# EXHIBIT 6

**Rebuttal Response to:**  
**Reports of Alexandros Spiliotopoulos, Remy J.-C.**  
**Hennet & Jay Brigham**

Morris L. Maslia

**Figure 4.1.** Plot of Modeled Concentration of tetrachloroethylene (PCE) with source release date variation: A, water-supply well TT-26 and B, Tarawa Terrace water treatment plant (TTWTP)

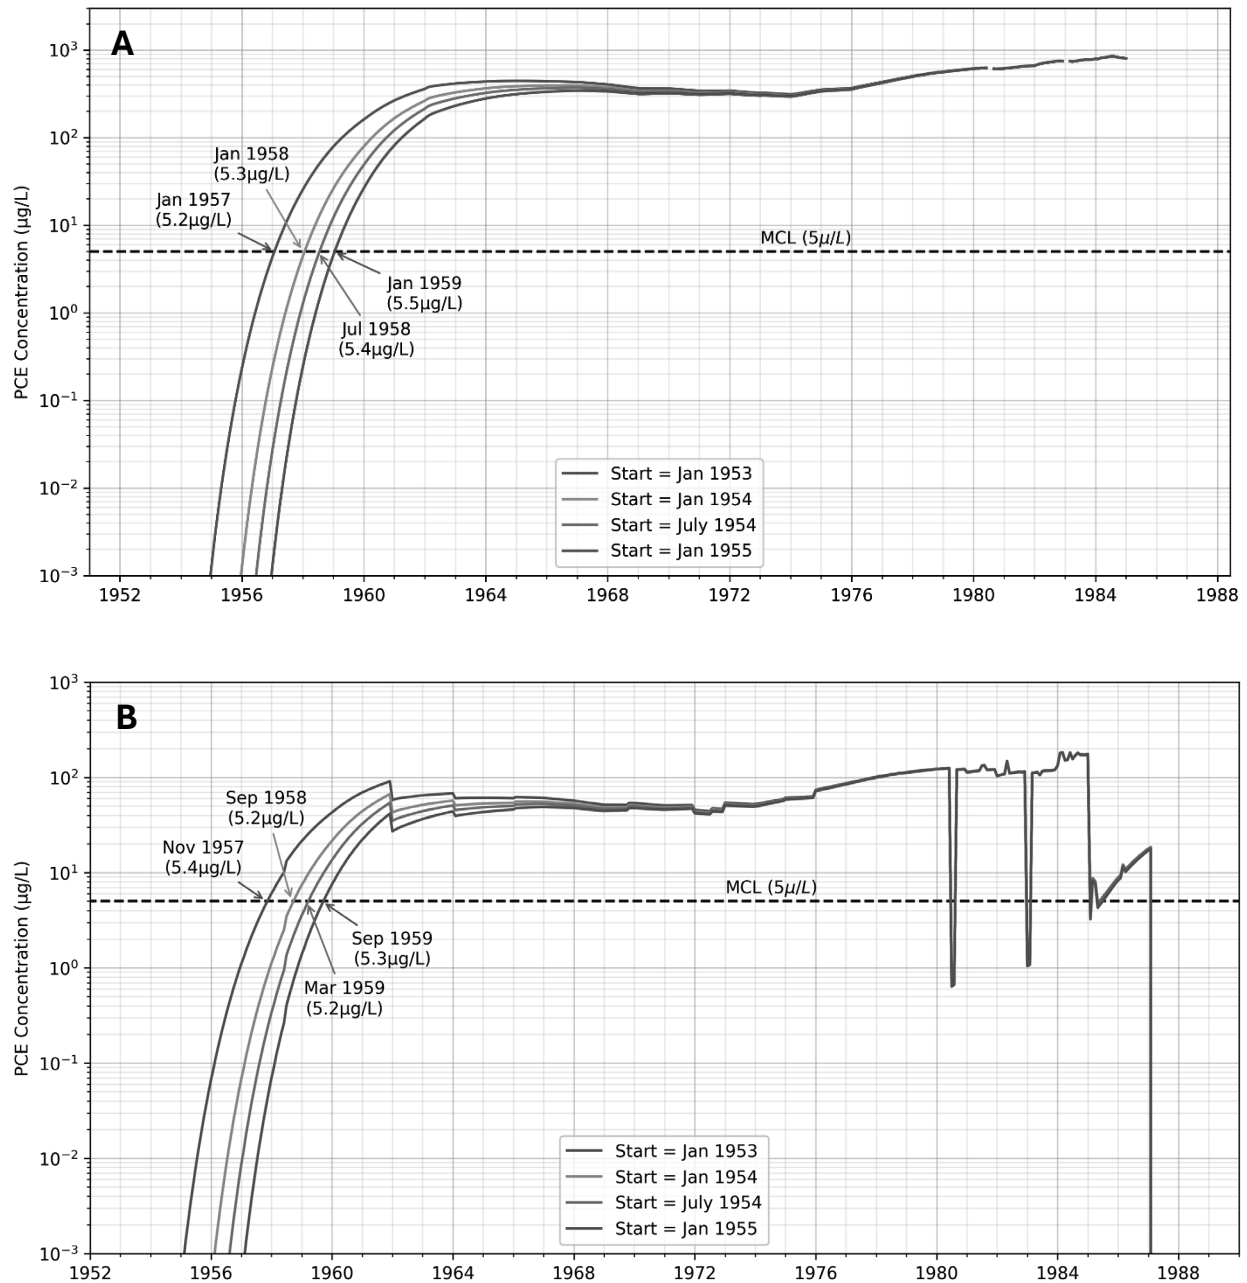
Results of varying the start dates of operations at ABC One-Hour Cleaners (source release date) are shown in Figures 4.1A and 4.1B for reconstructed PCE concentrations at water-supply well TT-26 and the Tarawa Terrace water treatment plant (TTWTP), respectively. These results show that the calibrated TT modeled PCE concentrations are insensitive to these variations in source release date throughout much of the exposure period since these variations make a negligible difference in PCE concentrations from the calibrated reconstructed concentrations for the duration of the epidemiological study (1968-1985)<sup>4</sup>, as listed in Table 4.1. Additionally, the dates that the maximum contaminant level (MCL) for PCE of 5 ug/L is exceeded at water-supply well TT-26 and at the TTWTP, the duration of exceedance (in months), and the maximum reconstructed concentrations are listed in Table 4.2. Note the negligible changes from the calibrated ATSDR model results due to the variable start dates (Maslia et al. 2007; Faye 2008). Based on this sensitivity analysis, I conclude that the ATSDR calibrated models for reconstructing PCE concentrations are not sensitive to the start date of operations (source release date) at ABC One-Hour Cleaners. I stand by the ATSDR start of operations at ABC One-Hour Cleaners of January 1953, as documented in the sworn testimony of Victor Melts (2001) and applied by Faye (2008) as a more reliable start date.<sup>5</sup>

**Figure 4.2.** From Maslia et al. (2013), Figure A9

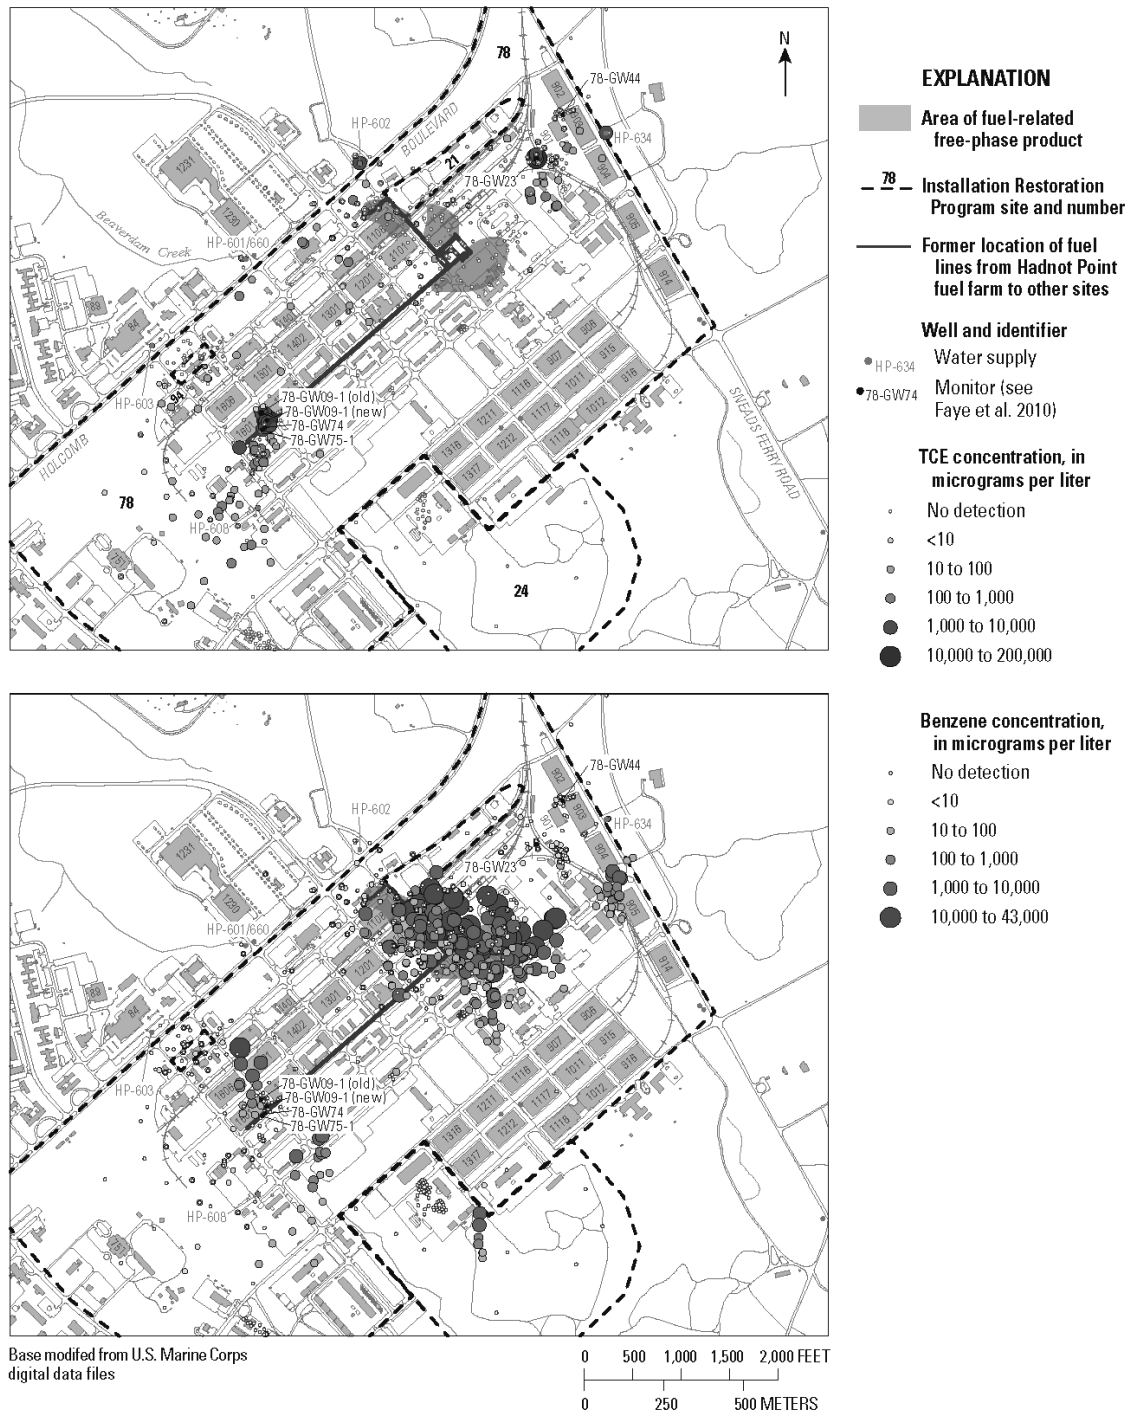
ATSDR does indeed discuss the lack of data to define the source loading terms for the model in the Hadnot Point Industrial Area (HPIA) and Hadnot Point landfill (HPLF) areas. However, as Dr. Konikow (2025) notes and I agree, there is no doubt that these chemical contaminants (including TCE and PCE) were present in the groundwater at toxic concentrations (substantially exceeding the MCLs<sup>6</sup>) in these areas, and that they were pumped out of the aquifer by several operating water-supply wells shown in Maslia et al. (2013, Figures A9 and A10) and provided below as Figures 4.2 and 4.3.

**Figure 4.4.** From Faye (2008), Figure F16.

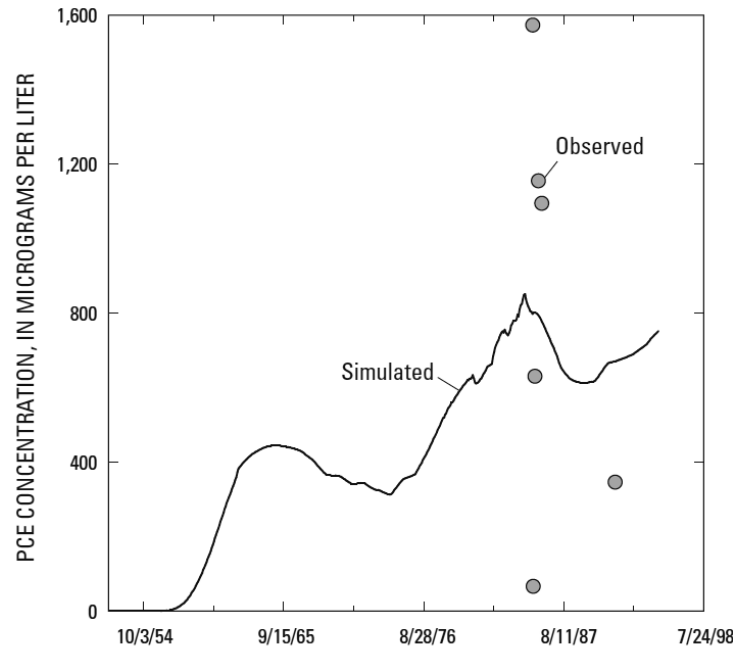
With respect to calibrated ATSDR models being “biased high” as posited by DOJ experts, the opposite is true. For example, Figure 4.4 from Faye (2008, Figure F16)<sup>7</sup> shows a plot of observed data (5 of the 6 samples were obtained within a week’s time) and reconstructed PCE concentrations for water-supply well TT-26. Note that the highest and first sample was taken during the period when this well was in service, as compared to the remaining samples when this well was out of service. If anything, it could be argued that the model is under-predicting the concentrations. Furthermore, note that reconstructed PCE concentrations fell almost exactly at the midpoint of the range of observed values (about 800 ug/L)—countering the claim of being biased high and confirming the adequateness and acceptability of the calibrated ATSDR models including the reconstructed supply-well operations. As with well TT-23 discussed above, the first sample from well TT-26 was taken when it was operating, and the remainder of the samples were taken after well TT-26 was permanently removed from service.

In his Opinion 2, AS (2024, p. 33) reproduces ATSDR’s Figure F16 (Faye 2008)<sup>25</sup> of TT historical reconstruction results at water supply well TT-26, and states that ASTDR’s work resulted in “biased high estimates.” As Dr. Konikow notes, Figure F16 (provided in this report as Figure 4.4 in Section 4.2.1) illustrates the opposite and instead “shows 5 measured PCE concentrations in samples from well TT-26 collected within weeks of each other in early 1985. Over this relatively short time span, the concentrations varied greatly (bracketed between a high of 1,580 µg/L on 01/16/1985 to a low of 3.8 µg/L on 02/12/1985)—a rate of change that cannot be replicated in a model using monthly time steps. Most importantly, the plot shows that the model results fell almost exactly at the midpoint of the range of observed values (about 800 ug/L)—countering the claim of being biased high.” (Konikow 2025)

**Figure 4.5.** Reconstructed historical pumping operations for well HP-651 (from Telci et al. 2013)

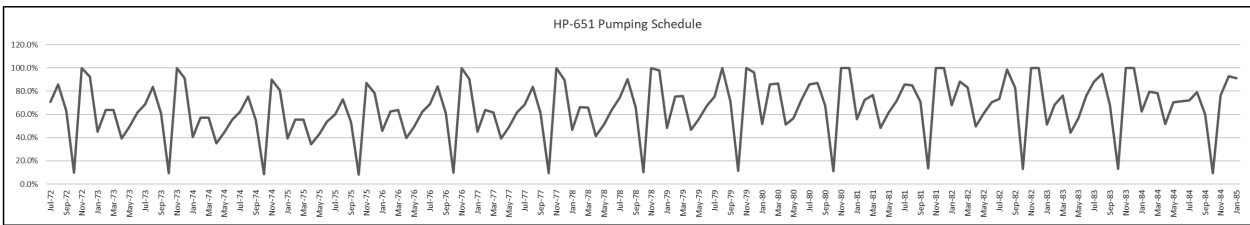
The fact that well HP-651 only operated at 6% could also be attributed to the pumping schedule being used at the time. As outlined extensively in ATSDR's reports (Telci et al. 2013),<sup>13</sup> ATSDR used current (2008) pumping data as a "training period" to reconstruct well operations during the historical period ("predictive period"). On those wells that were shut down due to contamination, "surrogate wells" were used for the "training period" (Telci et al. 2013, Table S2.2)<sup>14</sup>. HP-651 was shut down in February 1985 so well HP-633 was used as its surrogate. If we look at the historic pumping schedule that was created for HP-651 based on HP-633 we see there is a cycle:

In the reconstructed pumping operations cycle, well HP-651 drops below 10% every October. This cycling was common for several reasons, including substantial reductions in consumption and demand owing to deployment of troops and climatic conditions where October and generally Fall to early Winter are "wet months." It is very possible that the actual low-cycle month for HP-651 was December and not October, which would explain the 6% value of operation time for December of 1984.

**Figure 4.6.** Comparison of tetrachloroethylene (PCE) reconstructed concentrations for variations in retardation factor for: (A) water-supply well TT-26, and (B) Tarawa Terrace water treatment plant (TTWTP). Note:  $R = 2.93$  is calibrated retardation factor from Faye (2008).

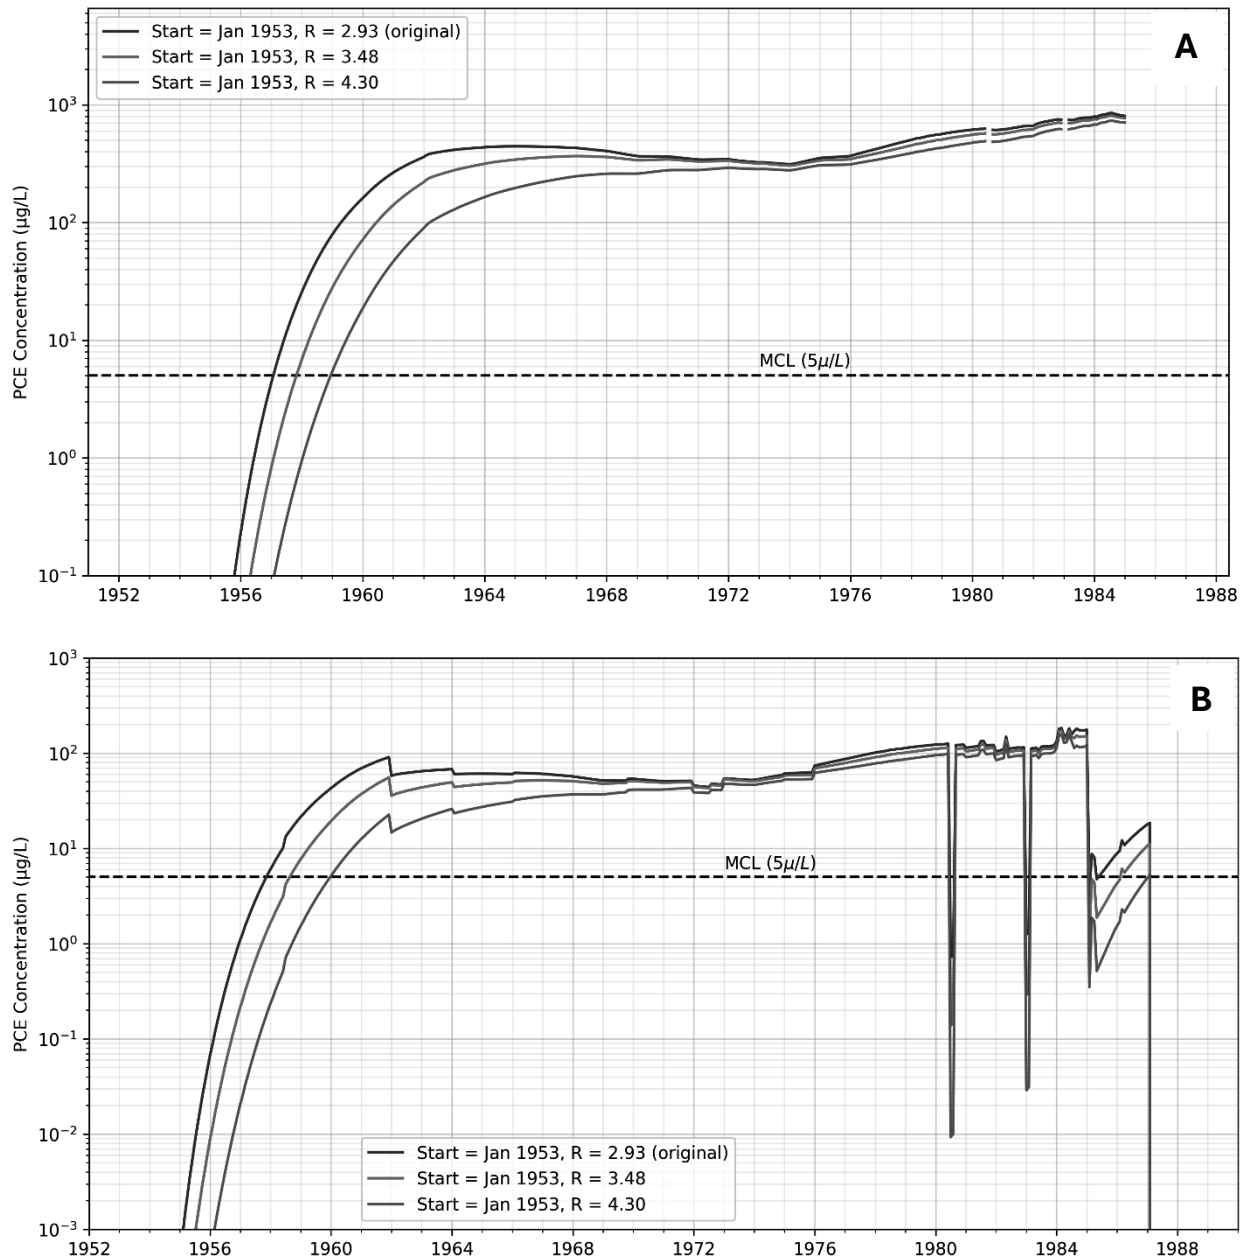
To test the effect that variations in  $R_f$  have on PCE concentrations at water-supply well TT-26 and the TTWTP, a series of simulations were conducted wherein the calibrated retardation factor of 2.93 (Faye 2008) was increased to 3.48 and 4.3 as speculated by AS and RH. As these sensitivity analyses (variations in retardation factor) demonstrate in Figure 4.6 below, the model is insensitive to changes (increases) in the retardation factor. After 1960, simulated results show PCE concentrations at TT-26 and at the TTWTP more than the MCL for PCE of  $5 \text{ } \mu\text{g/L}$ .

**Figure 4.7.** From Maslia et al. (2013), Figure A25.

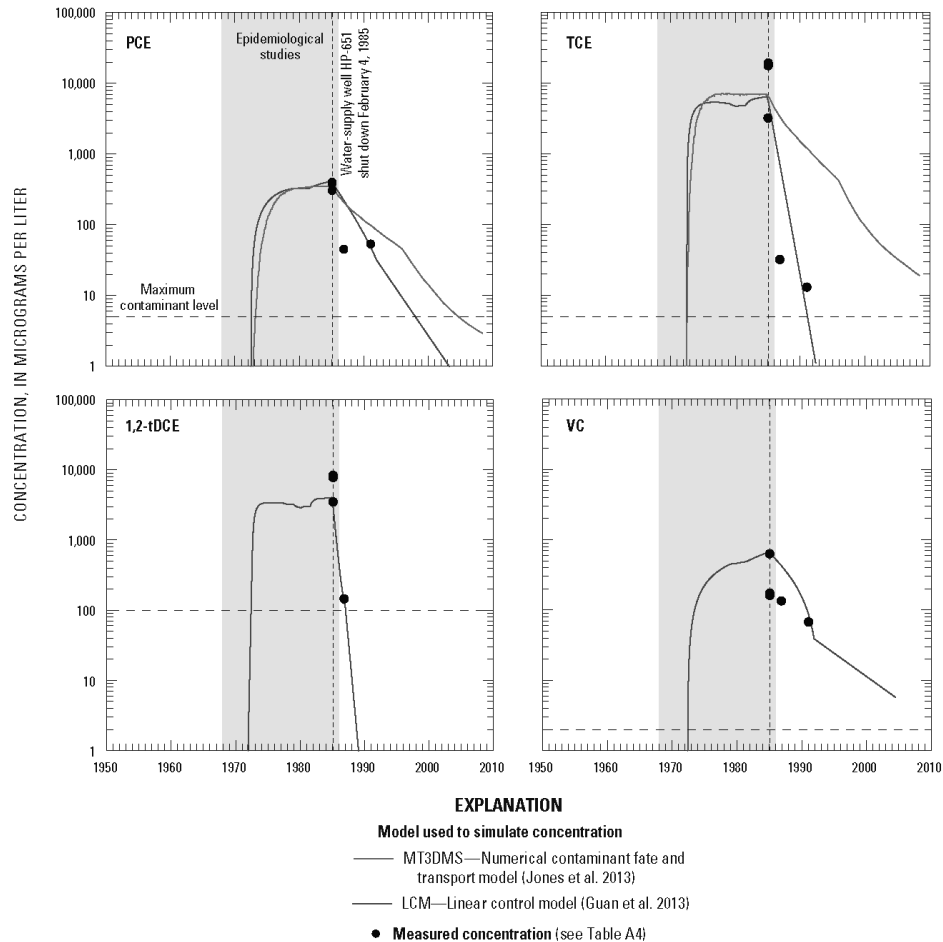
In section 4.2.4 (p. 82-83), AS states that “As illustrated in Figure 33 [ATSDR Figure A25], the historical reconstruction prior to 1985 cannot be verified, due to lack of observed data for the period.” As I have stated previously, and as Dr. Konikow also opines, this is the reason why a simulation model was needed and was developed. For the four contaminants shown in Figure 4.7 the agreement between simulated values and observed data where data was available is excellent in all four plots. If anything, the model results for TCE and 1,2-tDCE are below the peak sampled data points, again suggesting that the model is under-predicting these concentrations. “This close agreement when observations are available builds confidence in the reliability of the model and its predictions,” including for the historical reconstruction results for times prior to 1985. (Konikow 2025). The objective was to use a technically sound model that would be calibrated to available data in and after 1985, and to estimate the values during the 15 or so years prior to that calibration period to inform the epidemiological studies.

The objective was to use a technically sound model that could be calibrated to available data in and after 1985 and to estimate the values during the 15 or so years prior to that calibration period to inform the epidemiological studies. As Konikow (2025) observes, for PCE and TCE, the fit with the LCM model was slightly better than with the MT3DMS model, which was not designed to simulate degradation products. The excellent quality of the fit is illustrated in Figure 4.7.
